Intersection ID: 10033082	Main Street: NORTH_REA_PARK_LN	Cross Street: N/A	Location:	S
ADA ID: BD18DC8D8638	Ramp Type: Perp	Initial Pass/Fail: Fail	Overall Compliance: No	Severity Score: 12.5

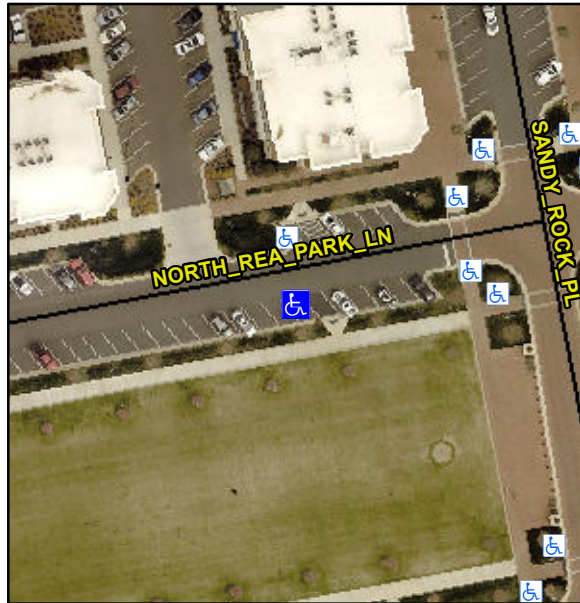
Not Found, R304.2.2

Compliance	Description	Data	Compliance	Description	Data
N/A	Ramp Length (in)	95.0	No	Ramp Slope (%)	11.3
Yes	Ramp Width (in)	59.5	Yes	Ramp XSlope (%)	1.6
N/A	Flare Type LT	N/A	N/A	Flare Type RT	N/A
N/A	Flare Slope LT (%)	N/A	N/A	Flare Slope RT (%)	N/A
N/A	Flare Traversable LT?	N/A	N/A	Flare Traversable RT?	N/A
N/A	Landing Length (in)	N/A	N/A	DWS Provided?	N/A
N/A	Landing Width (in)	N/A	N/A	DWS Contrast?	N/A
N/A	Landing Slope (%)	N/A	N/A	DWS Length (in)	N/A
N/A	Landing X Slope (%)	N/A	N/A	DWS Full Width?	N/A
N/A	Landing Curb? (Y/N)	N/A	N/A	DWS Offset (in)	N/A
N/A	Shared Landing?	N/A			
N/A	Gutter Ponding?	N/A	N/A	Gutter Slope (%)	N/A
N/A	Gutter Lip Ht (in)	N/A	N/A	Gutter X Slope (%)	N/A
N/A	Painted X Walk1?	No	N/A	Painted X Walk2?	N/A
	X Walk 1 Direction	To N		X Walk 2 Direction	N/A
N/A	X Walk 1 Width (in)	N/A	N/A	X Walk 2 Width (in)	N/A
	X Walk 1 Slope (%)	6.7		X Walk 2 Slope (%)	N/A
	X Walk 1 X Slope (%)	0.8		X Walk 2 X Slope (%)	N/A

Remove & Replace Entire Ramp.
